STP Post-meeting Notes for January 26-27, 2012 Public Meeting

- *Rick Grantom, PE Nuclear Eng.*
 - Manager, Risk Management Projects, South Texas Project Nuclear Operating Company
 - STP/Industry/NRC Coordinator for STP Risk-informed GSI-191 project

Fig1. The schematic representation of PRA & CASA Grande in the STP Risk-Informed GSI-191 project

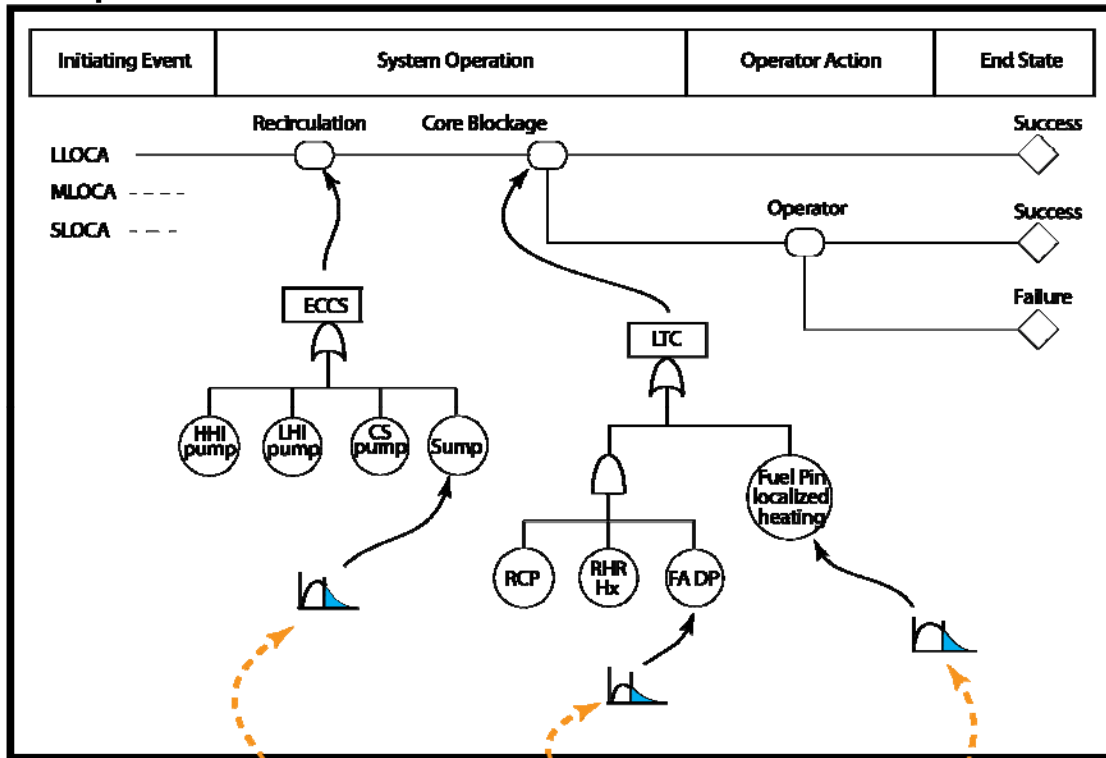
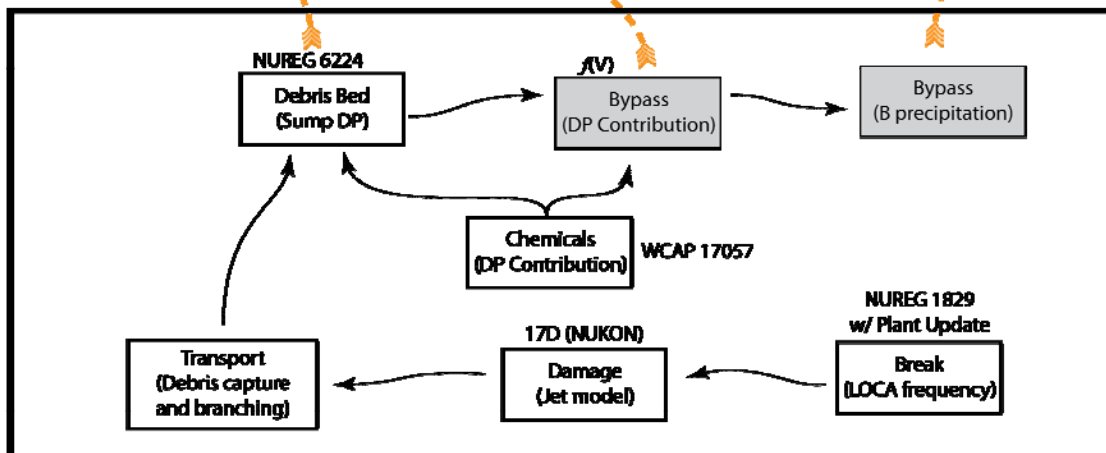
In view of this, the response to the question/comment about the cut sets in this project would be “we have the typical cut sets of Power Plant PRA”

And the response to the comment on CASA Grande being a black box is that “CASA Grande is **not** a black box but is, in fact, instrumental in opening the black boxes of two important events in the scenarios of a Power Plant PRA (i.e. recirculation and core blockage) by model-based estimations of the likelihood of their underlying basic events”.

Figure (1), on the next page, shows the schematic interrelationship of PRA and CASA Grande in the STP Risk-informed GSI-191 project. The figure does not attempt to cover all PRA scenarios (to avoid complexity with the figure). The main purpose is to present and to clarify the relationship between PRA and CASA Grande.

In other words, rather than relying solely on historical failure data for these three basic events (something that a typical PRA does), the STP risk-informed project develops the models (in CASA Grande) for the underlying chemical and mechanical phenomena which lead to the three basic events. The output of CASA Grande will give a more accurate estimate of the likelihood of these three basic events and can then be imported to Fault Trees of the plant-specific PRA in order to calculate CDF.
